Subject: Application for Revision to Competent Authority Certification, USA/0653/AF-96 for the Model No. TNF-XI, RAI Response Revision, (Docket no. 71-3092) (EPID L-2018-LLA-0170)

**COR-19-021733-000 vers. 2.0, “Subject: request for additional information for review of the revalidation of the model no. TNF-XI packaging (docket no. 71-3092) (epid I-2018-IIa-0170)”**

Competent Authority Certification (CAC) USA/0653/AF-96  
Revision **Dk**  
Model No. TNF-XI

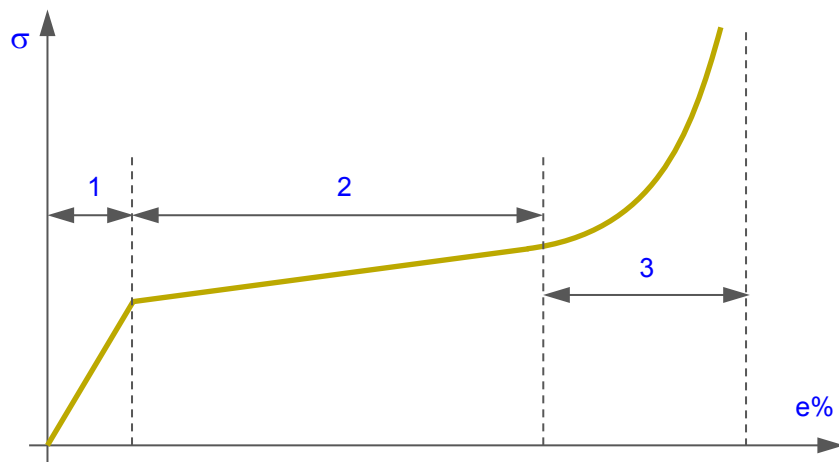
Although the applicant addressed the low-temperature mechanical performance of the phenolic resin, the applicant did not provide justification of adequate performance for the range of temperatures per IAEA SSR-6 regulations 639 and 679 (i.e., temperatures exceeding -40°C [-40 °F] up to 70°C [158 °F]). Per the discussion in Chapter 1, Appendices 1.1 and 1.2, this justification appears to be provided in either References 9 or 10 of Chapter 1 (i.e., Reference No. R&DDT001-26-B-2, Revision 1, “Synthèse d’essais de compression effectués en température sur des échantillons de mousse phénolique” or Reference No. NTC-05-00014263-000, Revision 0, “Note récapitulative sur le vieillissement en température des mousses phénoliques”). English translations of these references do not appear to have been included in the application. The staff needs this information to verify the applicant’s conclusion of adequate performance of the phenolic resin material in the temperature range of interest per IAEA SSR-6 regulations 639 and 679.

In addition, Chapter 0, Section 4.3, of the application states that each upper plug protecting the primary lids contains two thermal insulating disks with phenolic foam which provide thermal insulation and shock absorption. Per Chapter 0, Table 0.2, the phenolic foam for these disks is Type 3, which has a lower density and lower compressive strength than Type 1 and Type 2 used elsewhere in the package. The application does not justify the mechanical properties in Chapter 0, Table 0.2, per test results or a standard specification that demonstrate that the assumed values in the structural evaluation are valid for temperature range of interest per IAEA SSR-6 regulations 639 and 679.

References <9> and <10> of chapter 1 and the corresponding translations are given in enclosed documents (3) and (5).

Within the scope of the prolongation of the current certificates of the TNF-XI package (certificates valid until end of 2021), the behavior of the phenolic foam is being updated. Thus, new thermal and ageing tests have been carried out and currently, results are being analyzed. Conclusions of these tests will be provided for the next prolongation request.

In chapter 0, the mechanical properties of the phenolic foam given are given for temperature equal to 20°C. In the structural evaluation chapter 1 – appendix 1.1, it is assessed the behavior of the package for a drop onto an upper corner in function of the temperature. This assessment is based on the data given in the reference 9 of Chapter 1, given in enclosed document (3).
